Reference No: HDC (161)-MKS/IU/2022/302  
Addendum Date: 19<sup>th</sup> July 2022

## ADDENDUM 1

**Project Name:** Development and Operation of an Overwater Restaurant in Hulhumalé.

**Proposal Reference Number:** HDC (161)-MKS/IU/2022/269

DRAWING: SITE MAP

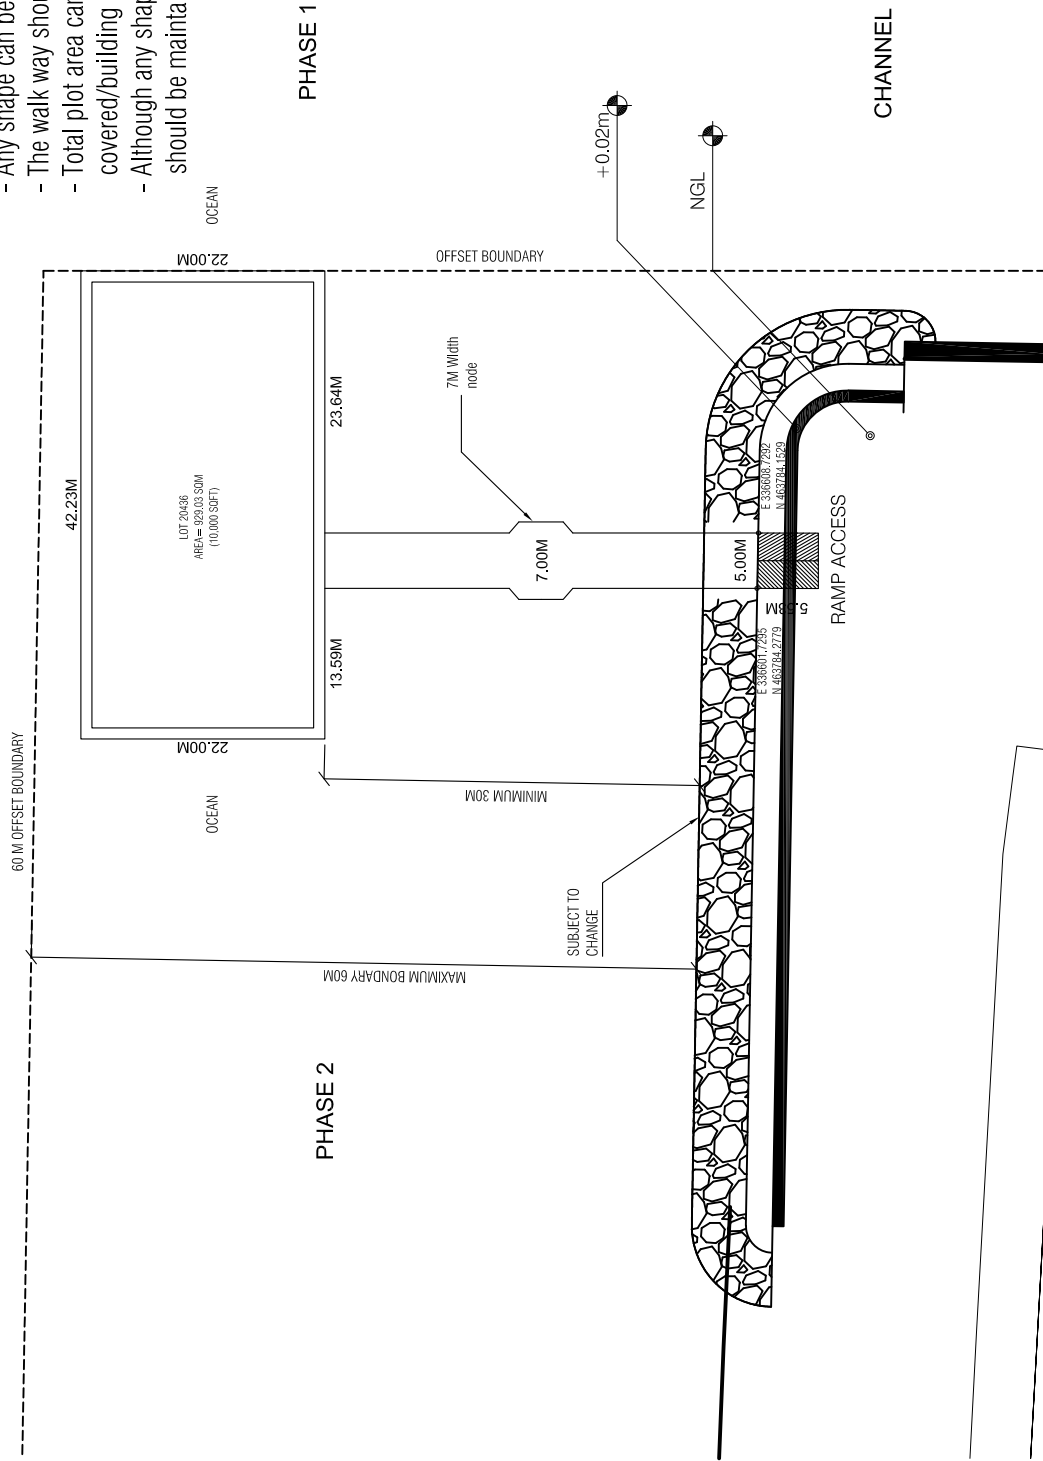
<p>HDC Building Huvandhumaa Hingun Housing Development Corporation Ltd</p> <p>Date: <b>04<sup>th</sup> August 2022</b></p> <p>Time: <b>14:00hrs</b></p>											
<p><b>Section II. RFP Data Sheet</b></p> <p><b>ITP 13.2</b></p>	<p>Bid Securities with a validity period of <b>167 (One Hundred and Sixty-Seven)</b> days from the deadline for submission of proposal, shall be accepted at the time of Proposal Opening.</p>											
<p><b>Section III. Lessors Requirements</b></p> <p><b>Clause 3.1 Project Cost Estimate by Lessor</b></p>	<p><b>Change:</b></p> <p>3.1. The Estimated Investment Cost for the Plot is <b>MVR 14,980,000.00</b> (Maldivian Rufiyaa Fourteen Million Nine Hundred Eighty Thousand). The minimum acceptable land price per square feet.</p>											
<p><b>Section III. Lessors Requirements</b></p> <p><b>Clause 4 Plot Details</b></p>	<table border="1"> <thead> <tr> <th>#</th> <th>Plot No.</th> <th>Usage</th> <th>Plot Area (Sqft)</th> </tr> </thead> <tbody> <tr> <td>1</td> <td>20436 (N1-75)</td> <td>Development and Operation of an Overwater Restaurant</td> <td>10,000.00</td> </tr> </tbody> </table>	#	Plot No.	Usage	Plot Area (Sqft)	1	20436 (N1-75)	Development and Operation of an Overwater Restaurant	10,000.00			
#	Plot No.	Usage	Plot Area (Sqft)									
1	20436 (N1-75)	Development and Operation of an Overwater Restaurant	10,000.00									
<p><b>Section VII. Drawings and Guidelines</b></p> <p><b>Clause 1 Drawings</b></p>	<p><b>Change:</b></p> <p>The drawing contains the location map and plot map of the land to be allocated for this RFP process. (Refer to next page).</p>											
<p><b>Section VII. Drawings and Guidelines</b></p> <p><b>Clause 2 Design and Development Guideline</b></p>	<p><b>Change:</b></p> <p>Design and Development Guideline. (Refer to next page).</p>

The shape of the plot line can be manipulated as per conditions below

- Development Should not go beyond the offset boundary
- Any shape can be proposed but it should have exactly the same area as proposed
- The walk way should be minimum 30M from land area. (as shown)
- Total plot area can be developed by the developer. However the maximum covered/building area can be up to 70% of the plot area.
- Although any shape can be proposed, a setback of 1 m from all side should be maintained for any building .

Lot Number	Parcel Number	Description	Land Use	Plot Area / Platform area	Foot Print/Building area	Gross Floor Area (G.F.A)	Plot Ratio (F.S.I)	Site Coverage	Max Height / Floors
20436	N1-75	Overwater Restaurant	Commercial	929.03 SQM 10,000.00 SQFT	650.32 SQM 7,000.00 SQFT	650.32 SQM 7,000.00 SQFT	0.70	70%	1 Floors / 5.5m 3.5m bldg. + 2m Pitched roof
